**NEW YORK STATE THRUWAY AUTHORITY
DEPARTMENT OF ENGINEERING**

**ALBANY, NY
JANUARY 30, 2024**

**AMENDMENT NO. 2
TO**

**CONTRACT TAA 23-25B
D214941
THRUWAY BRIDGE REHABILITATION
OVER THE WALLKILL RIVER, MP 81.72
IN THE ALBANY DIVISION
OF THE NEW YORK STATE THRUWAY
IN ULSTER COUNTY**

TITLE OF PROJECT REHABILITATION OF I-87 BRIDGES OVER WALLKILL RIVER	CONTRACT NUMBER: TAA 23-25B
LOCATION OF PROJECT ALBANY DIVISION MP 81.72	DATE: 01/24/2024
TITLE OF DRAWING WORK ZONE TRAFFIC CONTROL TYPICAL SECTIONS - STAGE 3	DRAWING NUMBER: TC-12

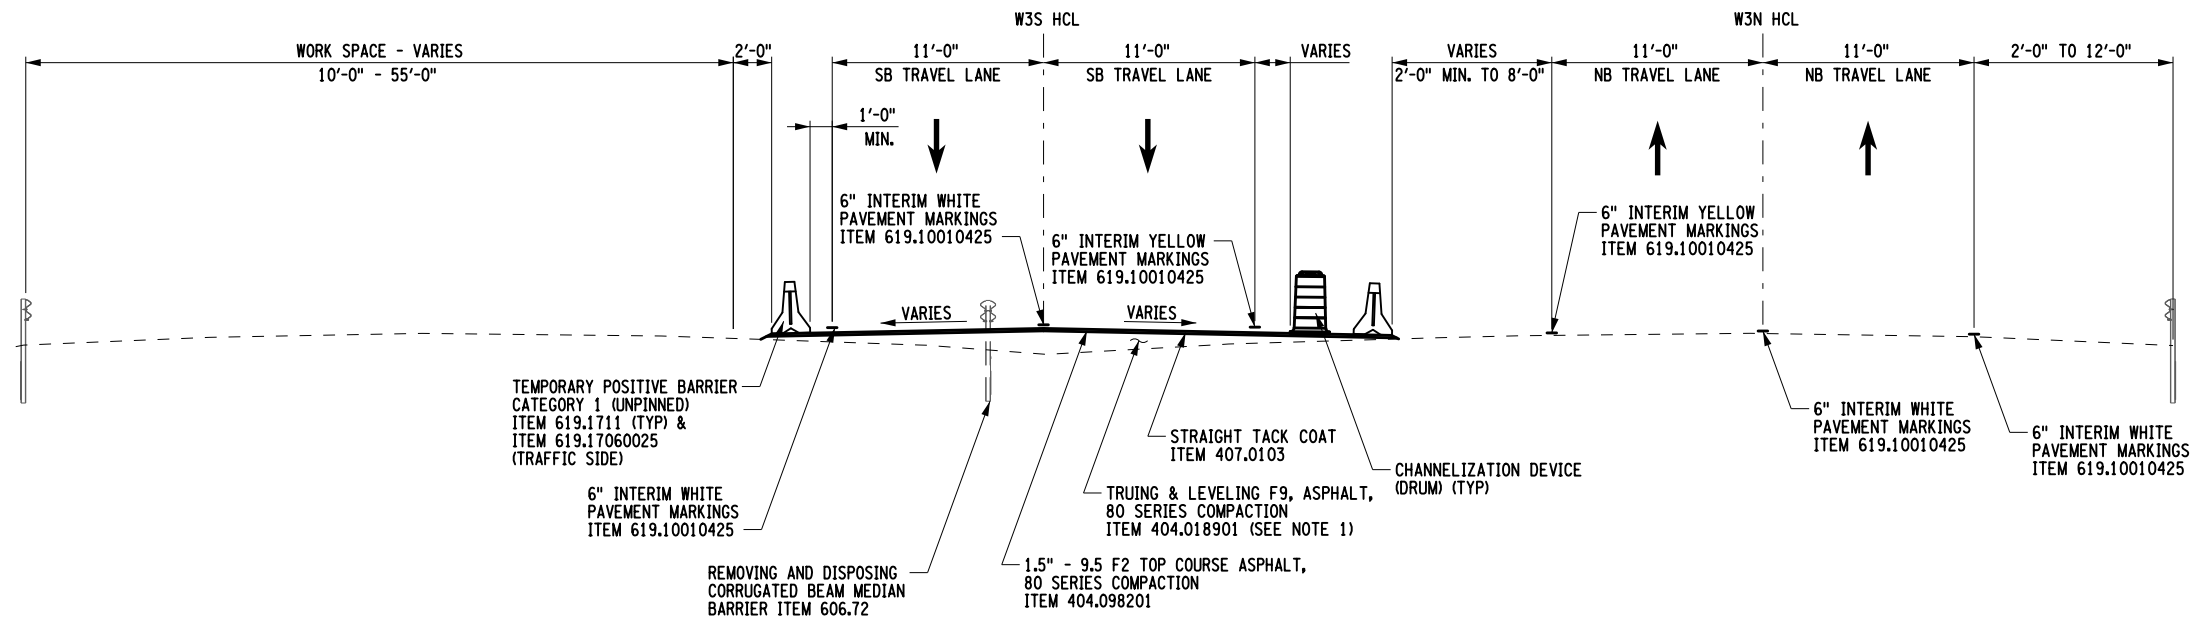
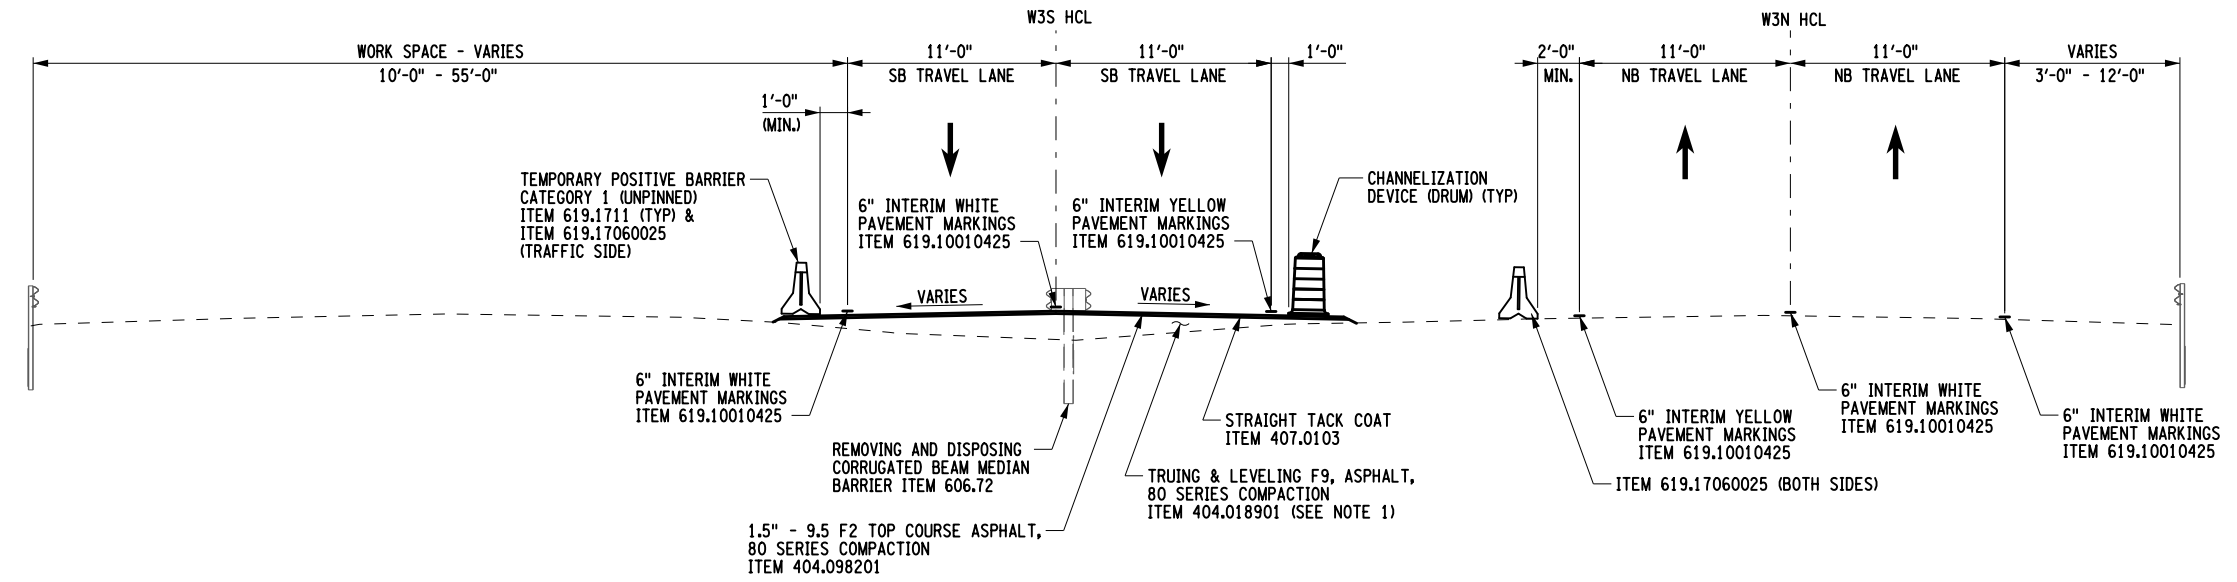
15. **DELETE** Drawing Number TC-12, Sheet 19 of 105 and **REPLACE** with the attached new Drawing Number TC-12-A2, Sheet 19-A2 of 105.
 - Change in Temporary Positive Barrier

TITLE OF PROJECT REHABILITATION OF I-87 BRIDGES OVER WALLKILL RIVER	CONTRACT NUMBER: TAA 23-25B
LOCATION OF PROJECT ALBANY DIVISION MP 81.72 - BIN 5041189	DATE: 01/24/2024
TITLE OF DRAWING EXCAVATION AND EMBANKMENT PLAN STAGE 2	DRAWING NUMBER: ST-09

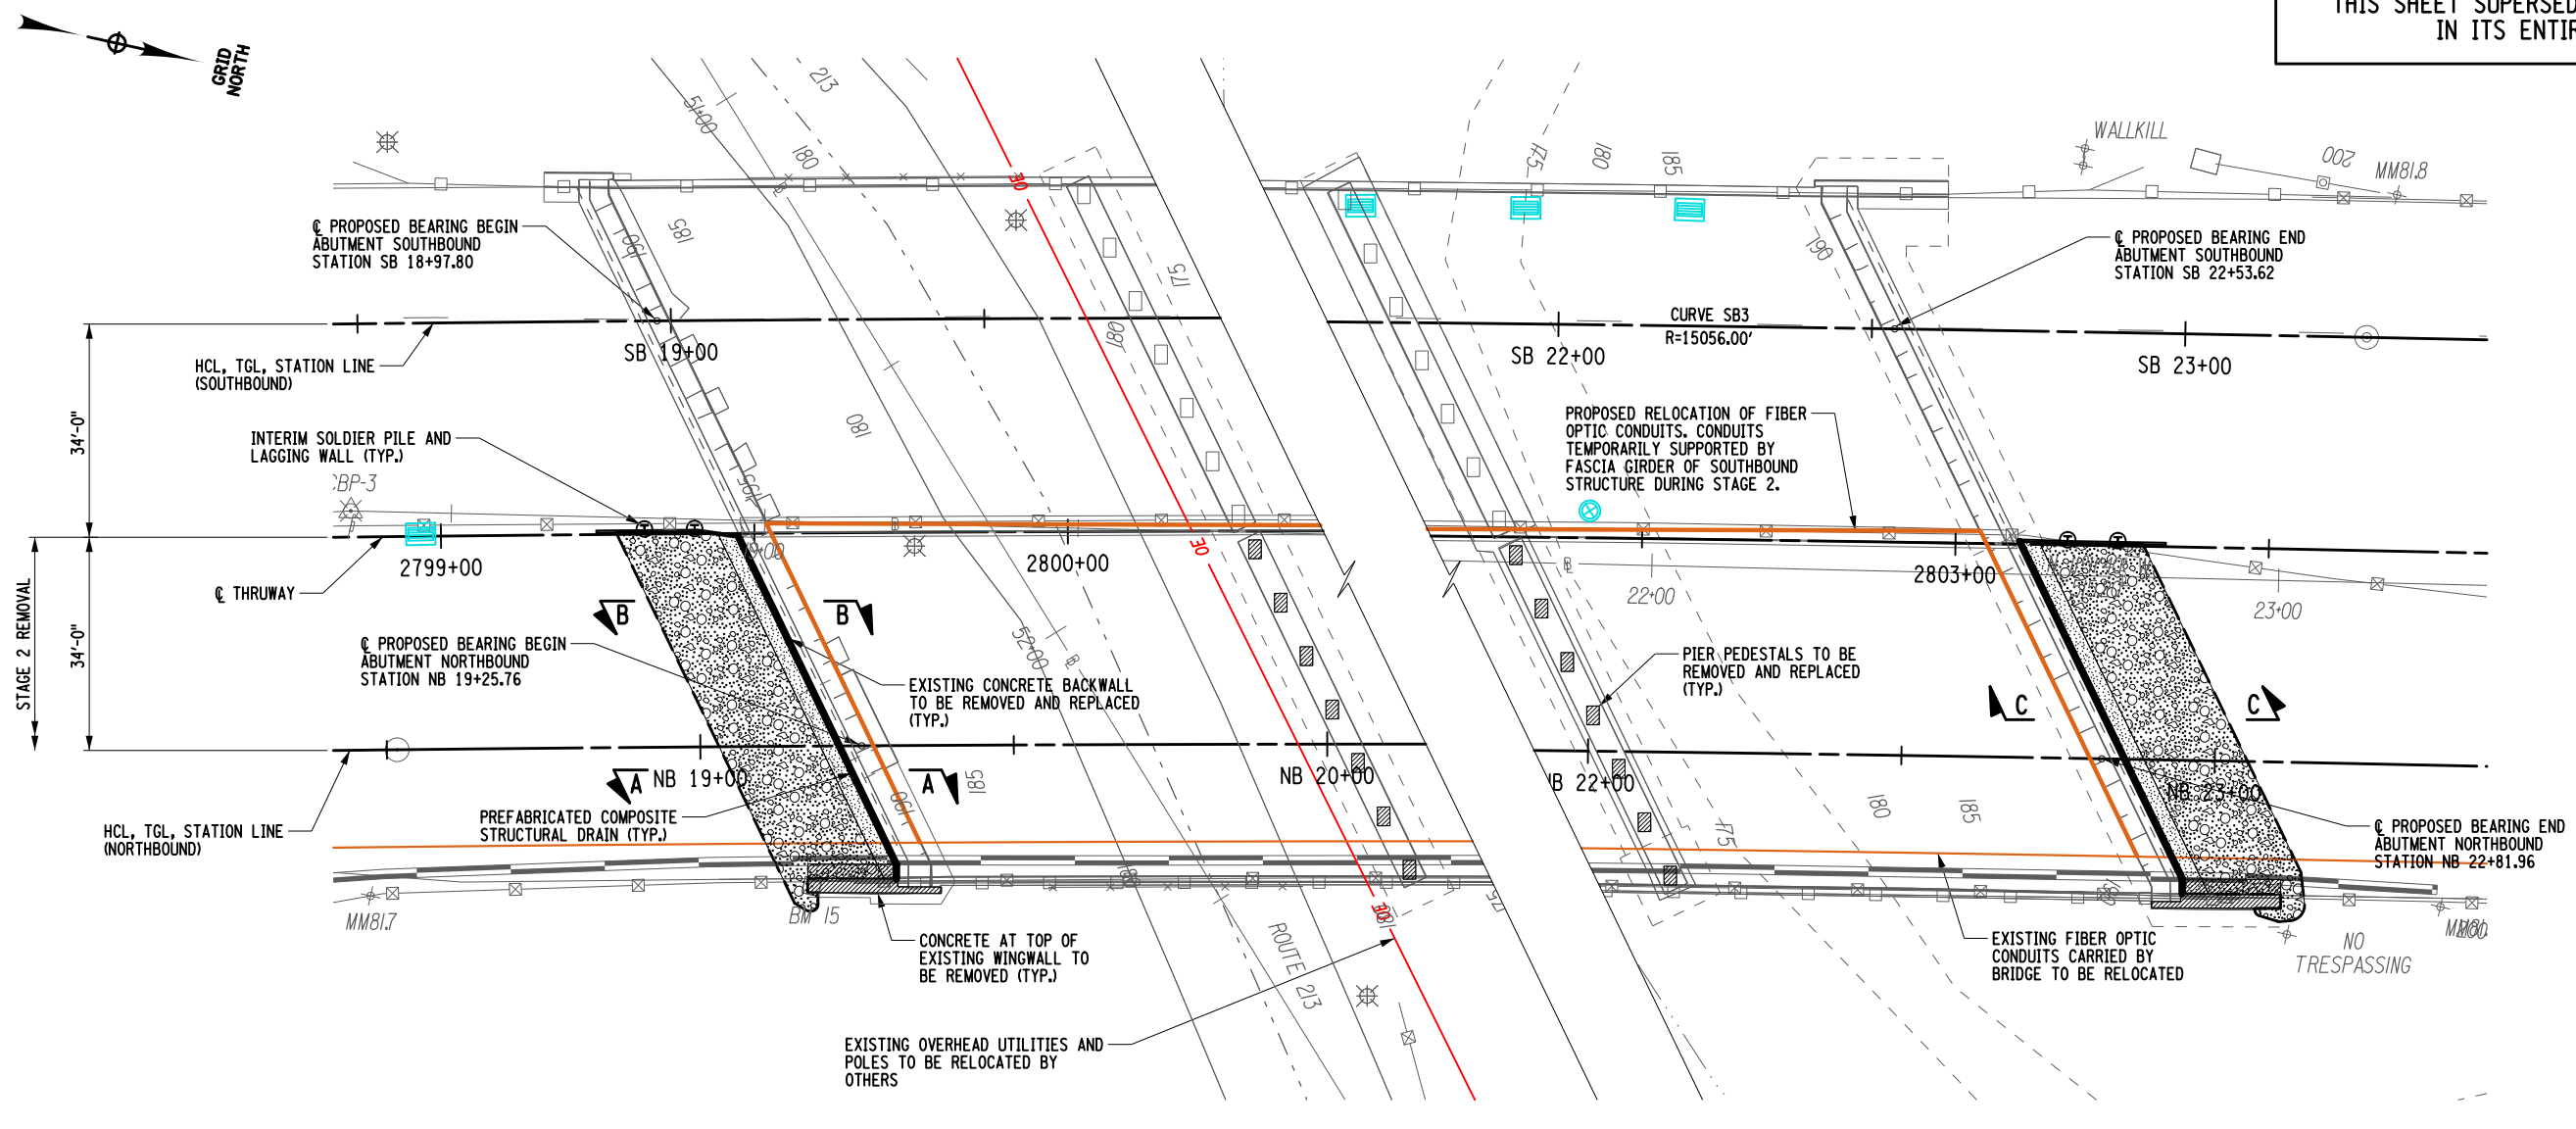
26. **DELETE** Drawing Number ST-09, Sheet 50 of 105 and **REPLACE** with the attached new Drawing Number ST-09-A2, Sheet 50-A2 of 105.
 - Note 3 has been updated

- Location of fiber optic conduit moved to the front face of abutments
 - Section marks have been added to match the Sections on Drawing Number ST-11
27. **DELETE** Drawing Number ST-10, Sheet 51 of 105 and **REPLACE** with the attached new Drawing Number ST-10-A2, Sheet 51-A2 of 105.

TITLE OF PROJECT REHABILITATION OF I-87 BRIDGES OVER WALLKILL RIVER	CONTRACT NUMBER: TAA 23-25B
LOCATION OF PROJECT ALBANY DIVISION MP 81.72 - BIN 5041189	DATE: 01/24/2024
TITLE OF DRAWING EXCAVATION AND EMBANKMENT SECTIONS	DRAWING NUMBER: ST-11

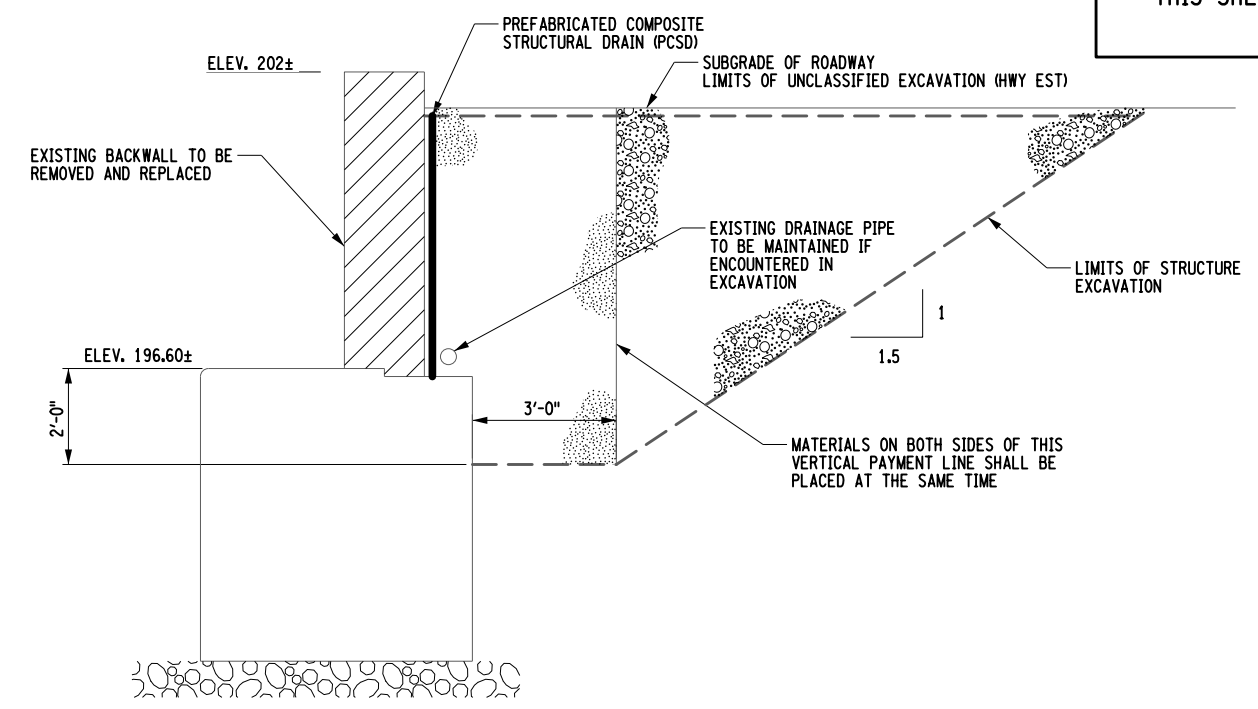
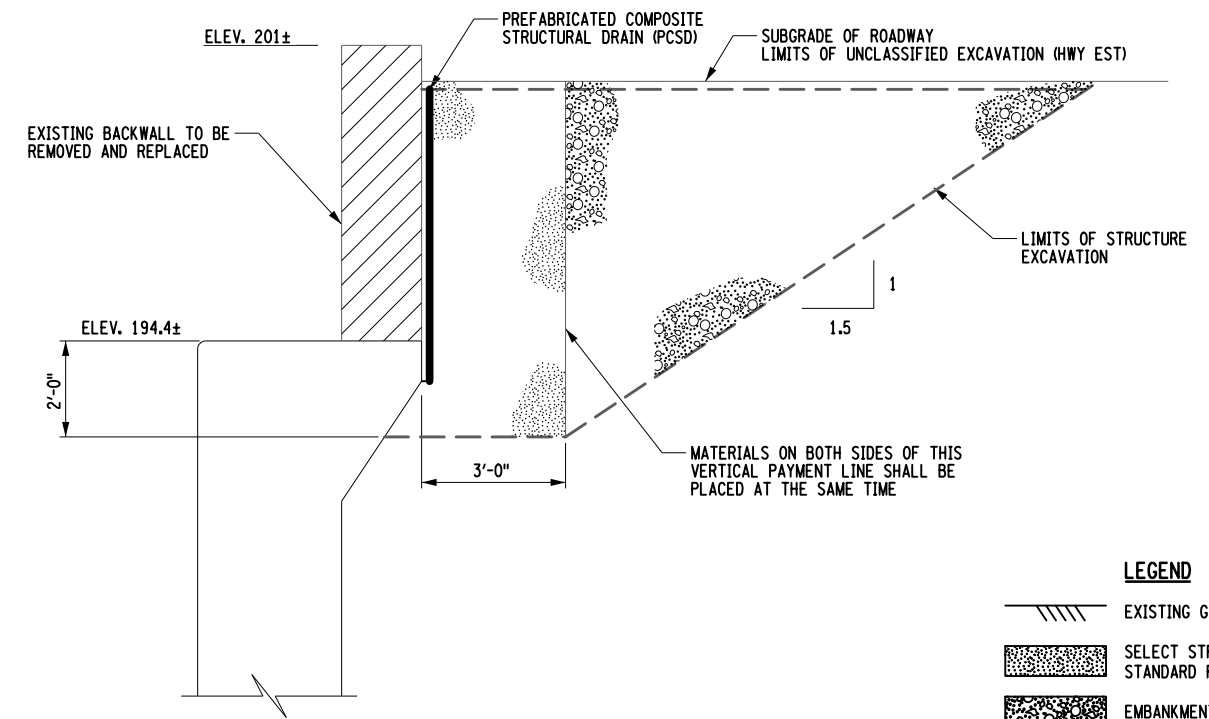
- Seat Elevations have updated
 - The limits of PCSD have been modified
 - Section marks have been updated to reflect the appropriate drawings in which the sections are located

- The Note regarding “EXISTING DRAINAGE PIPE TO BE MAINTAINED” has been appended with “IF ENCOUNTERED DURING EXCAVATION”
29. **DELETE** Drawing Number ST-12, Sheet 53 of 105 and **REPLACE** with the attached new Drawing Number ST-12-A2, Sheet 53-A2 of 105.

TITLE OF PROJECT REHABILITATION OF I-87 BRIDGES OVER WALLKILL RIVER	CONTRACT NUMBER: TAA 23-25B
LOCATION OF PROJECT ALBANY DIVISION MP 81.72 - BIN 5041189	DATE: 01/24/2024
TITLE OF DRAWING INTERIM SOLDIER PILE AND LAGGING WALL PLAN AND ELEVATION STAGE 3	DRAWING NUMBER: ST-13

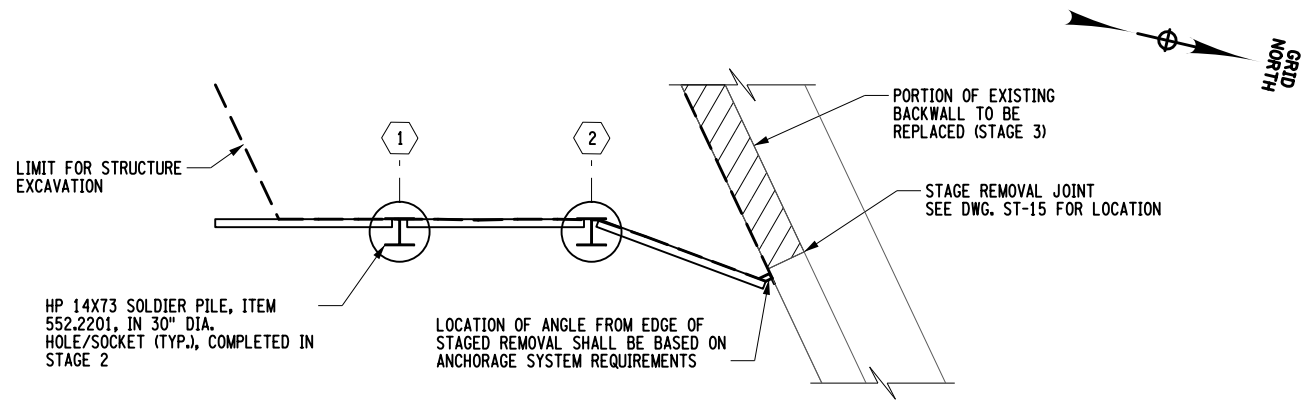
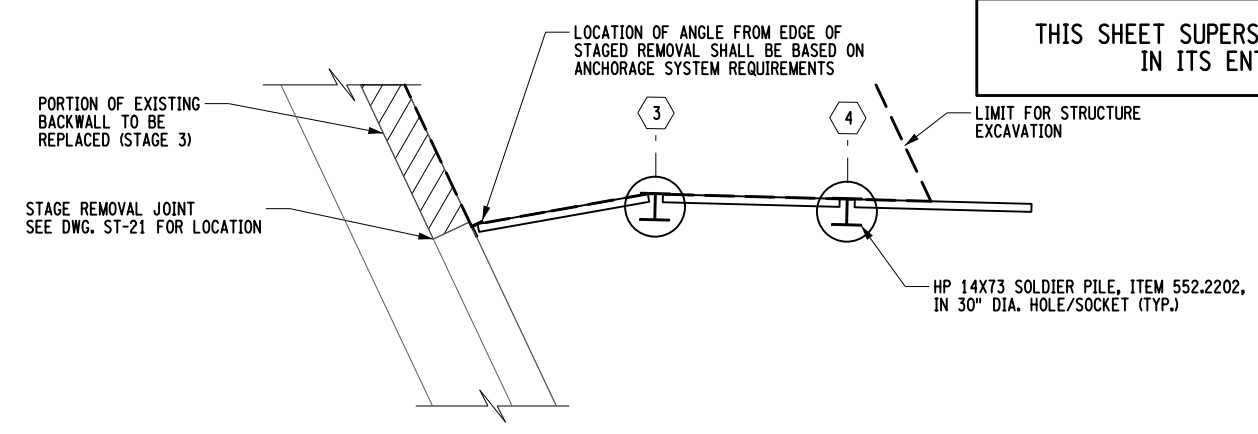
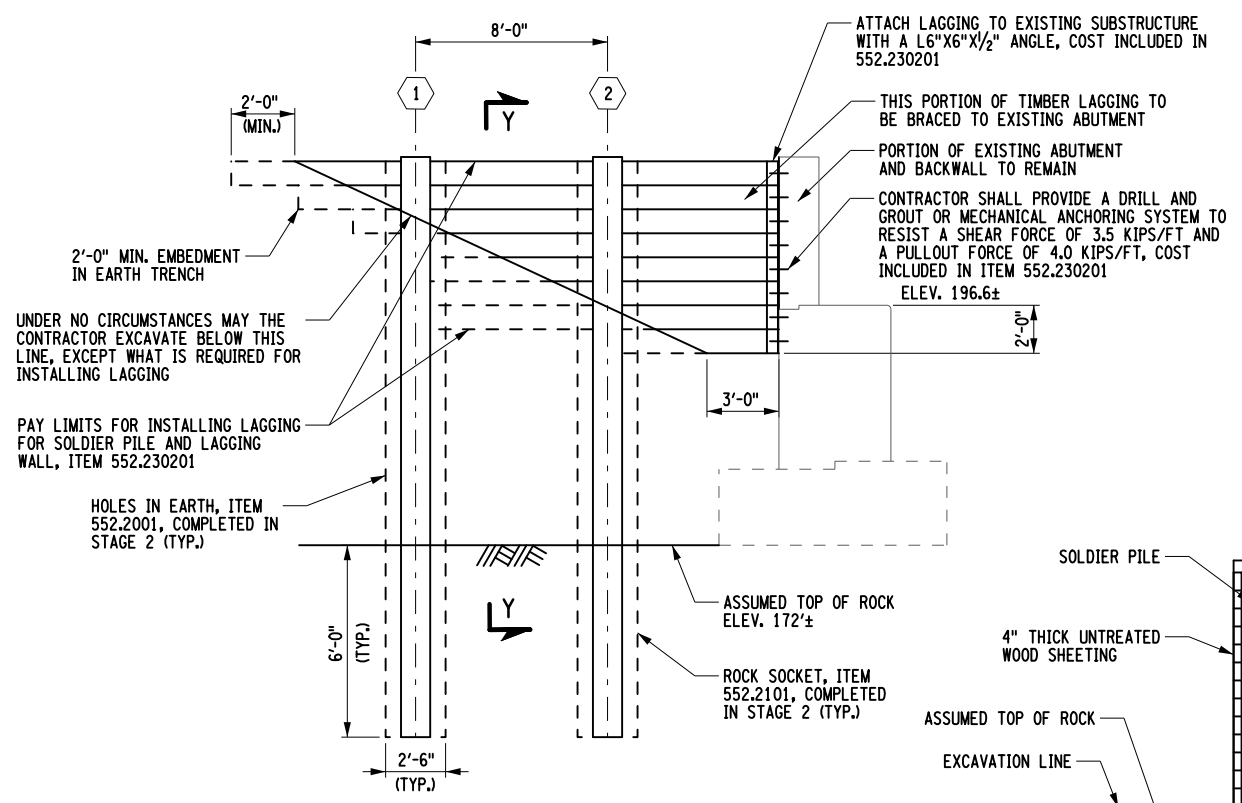
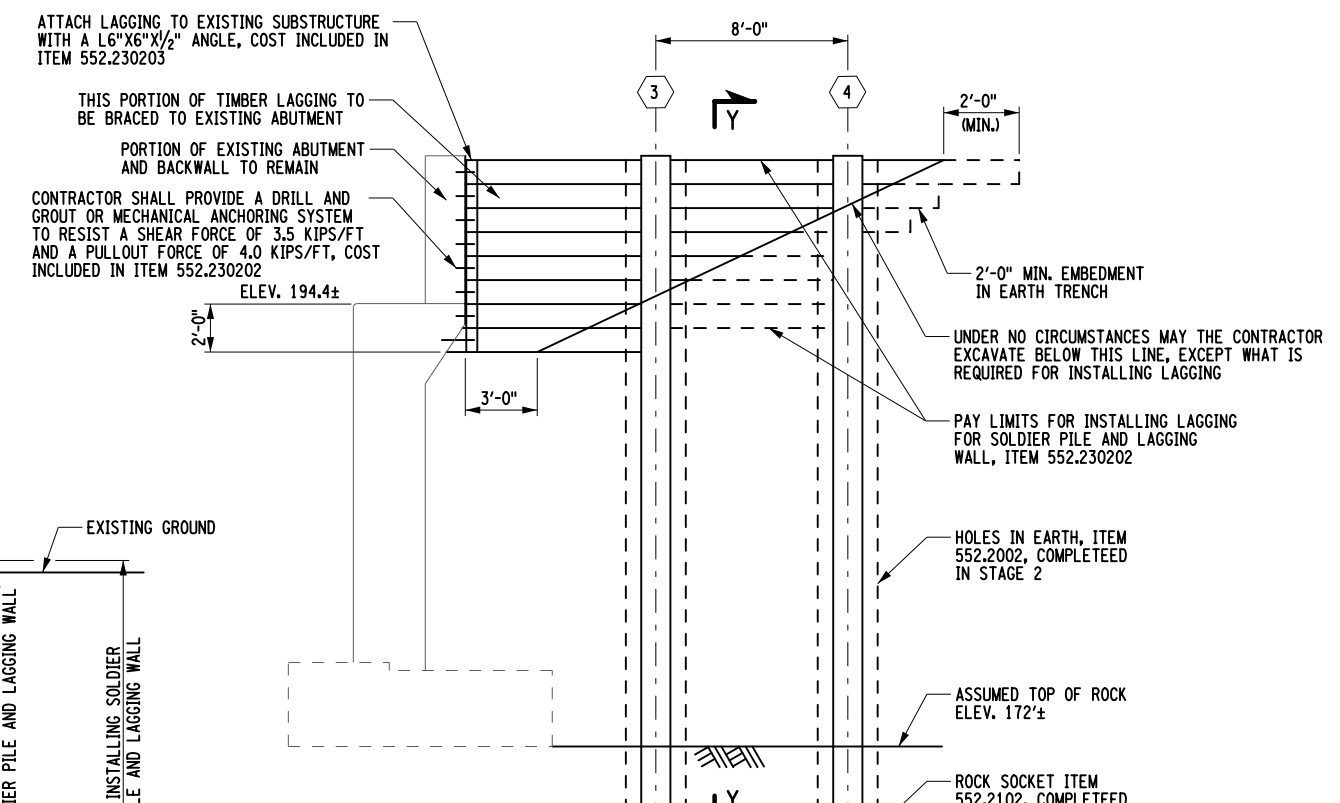
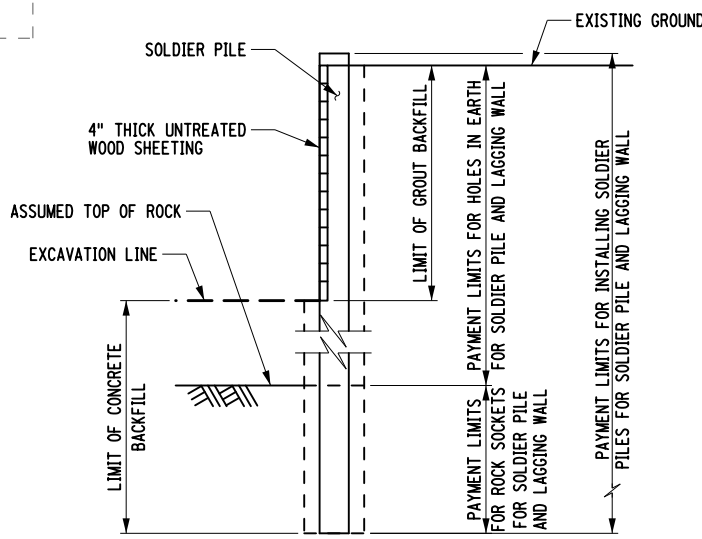
- The Pile numbers have been revised
 - Other minor annotation revisions
